UNITED STATES PATENT AND TRADEMARK OFFICE

APPLICATION NO.	FILING DATE	FIRST NAMED INVENTOR	ATTORNEY DOCKET NO.	CONFIRMATION NO.
10/756,379	01/14/2004	Markku Kakko	1381-0308P	2365

Office Action Summary

Paper No:02152005
Application No:10/756379
Filing Date: January 14,2004

FIG. 9

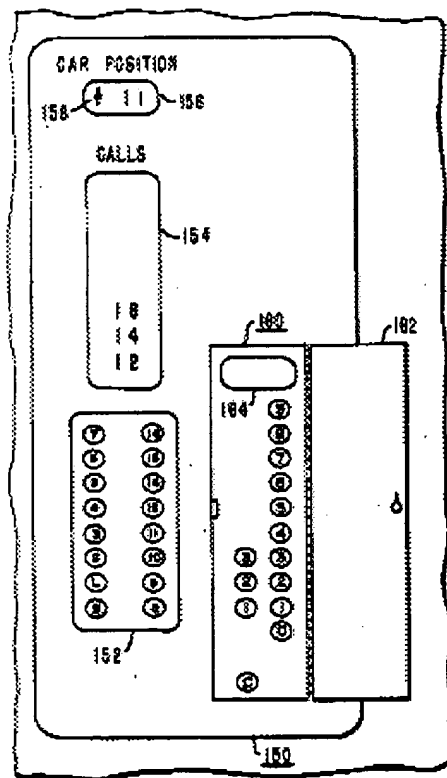
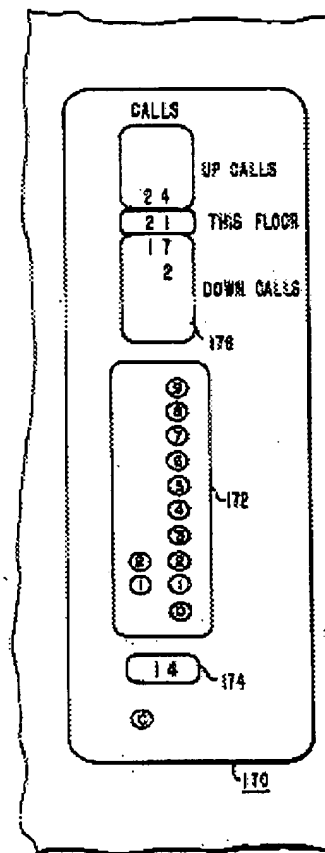
Mandel et al teaches in figures 1-10, an elevator display/operating

Destination floors 154,178 displayed in car and on floor.

Col. 1, lines 51-58 state display in order to be served in car and in order of associated floors in hall.

(interpreted by examiner to be "optimized").

Note arrow 156 for direction indication.
